SERVICE BULLETIN NO: 53-006

MODIFICATION NO: ECN 04-0416

FUSELAGE - FUSELAGE STRUCTURE INSPECTION FOR CORROSION IN FRAMES 3C AND REPLACEMENT OF WING ATTACHMENT BOLTS

FR 3C Assembly - Inspection and Replacement of Bolt Assembly
Figure 1

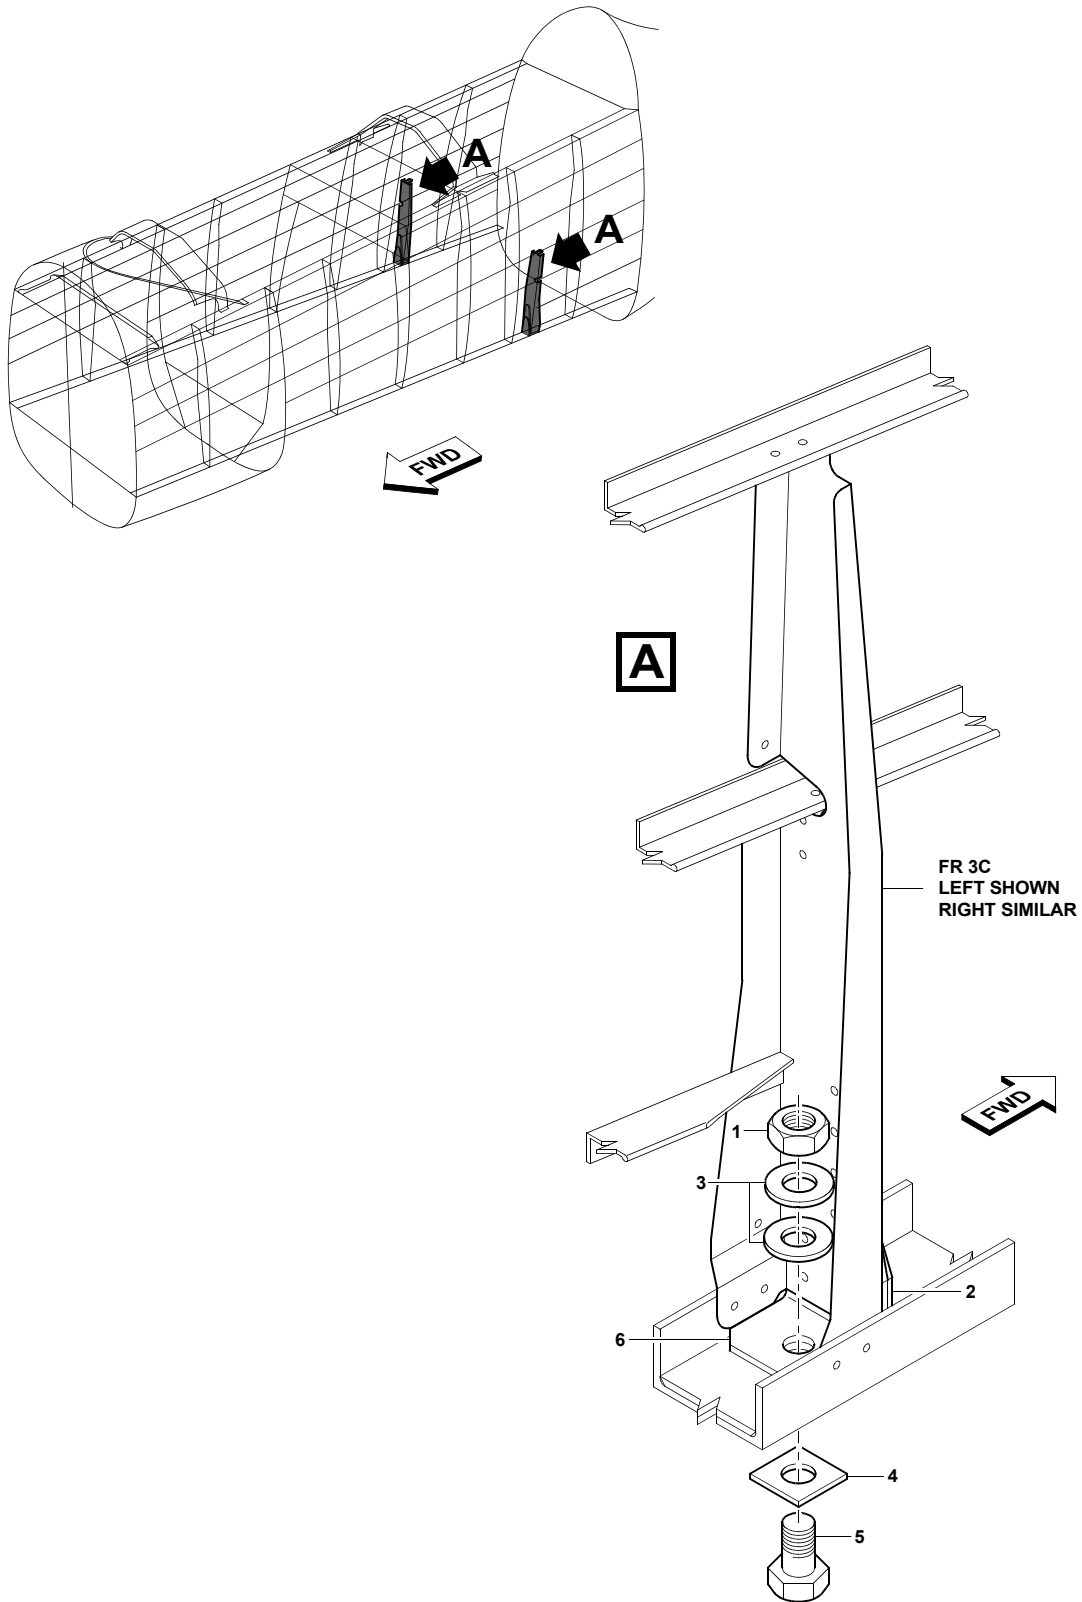
B. Structural Inspection and Replacement of the Bolt Assemblies (Ref. Fig. 1)

- (1) Remove and discard the left nut (1), washers (3) & (4) and bolt (5).
- (2) Obey the manufacturers instructions and use the solvent (Material Item No. P01-008 or approved alternative) to clean the surfaces of hole for the bolt (1).
- (3) Use a source of bright light and a X 10 magnifier to do an inspection for signs of corrosion:
 - In the hole for the bolt (1)
 - On the bracket (6), shear plate (2), FR 3C and the adjacent structure.

Corrosion is not permitted in the bolt holes. Surface corrosion on the bracket, shear plate or FR 3C assembly is permitted if in limits (Ref. SRM, 53-20-00, Page Block 101). All other types of corrosion in the bracket, shear plate, FR 3C or the adjacent structure is not permitted. You must:

- Remove surface corrosion (Ref. Step 4)
 - Replace the bracket, shear plate and FR 3C assembly together if you find corrosion in one or more of them (Ref. SRM, 53-20-00, Page Block 201):
 - Apply to PILATUS for instructions if you find corrosion in the skin or structure adjacent to FR 3C.
- (4) If necessary remove the surface corrosion (Ref. SRM, 51-10-02, Page Block 1). You must replace the bracket, shear plate and FR 3C assembly (together) if it is not possible to remove the surface corrosion and stay in limits.
 - (5) Obey the manufacturers instructions and apply layers of the corrosion preventative (Material Item No. P04-012) on the faying surfaces of the new bolt (5), washers (3) & (4) and the bolt hole.
 - (6) Assemble the bolt (5) and washer (4), put the bolt in position and install the washers (3) and nut (1).

- (7) Torque the nut (1) to between 26 and 28 Nm (230 to 248 lbf in.).
- (8) Obey the manufacturers instructions and use the solvent (Material Item No. P01-008 or approved alternative) to remove unwanted corrosion preventative.
- (9) Apply layers of the corrosion preventative (Material Item No. P10-015) on the FR 3C assembly and adjacent skin and structure.
- (10) Do Steps (1) thru (9) again to:
 - Do an inspection for corrosion in the right bolt hole, bracket (5), shear plate (6), FR 3C and the adjacent structure.
 - Replace the right bolt assembly
